SUBJECT: Forwards response to request for addl info re GL 96-06.

Subject: **WNP-2, OPERATING LICENSE NPF-21,
RESPONSE TO REQUEST FOR ADDITIONAL INFORMATION
RELATED TO GENERIC LETTER 96-06**

**RESPONSE TO REQUEST FOR ADDITIONAL INFORMATION
RELATED TO GENERIC LETTER 96-06**

FIGURE 1.21.-1

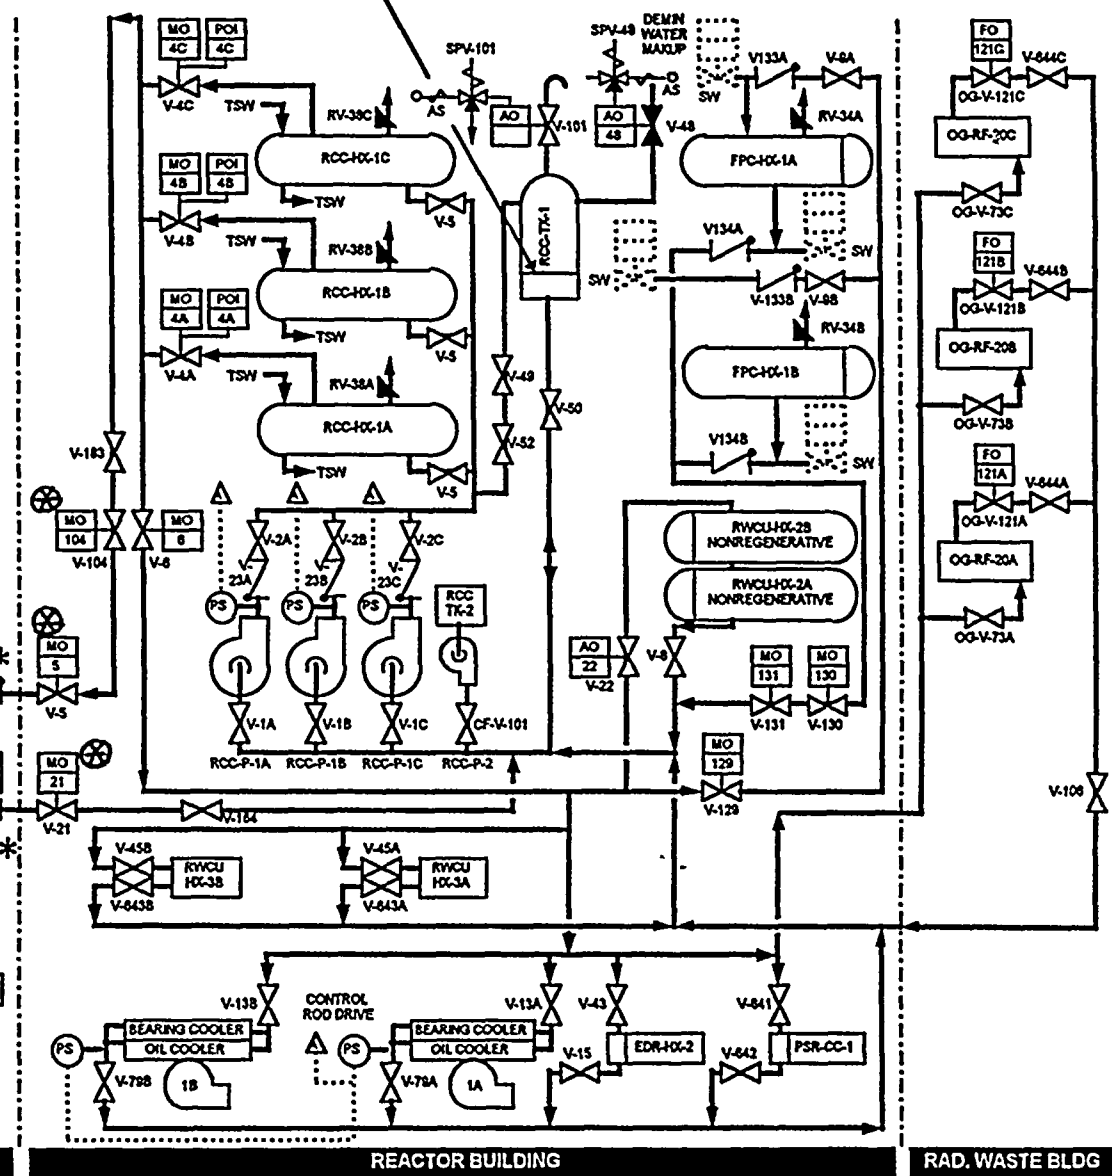
Provide a simplified diagram of the affected system, showing major components, active components, relative elevations, lengths of piping runs, and the location of any orifices and flow restrictions.

A simplified diagram is provided as part of this attachment. Piping run lengths were not provided because a detailed waterhammer and two-phase flow analysis was not performed.
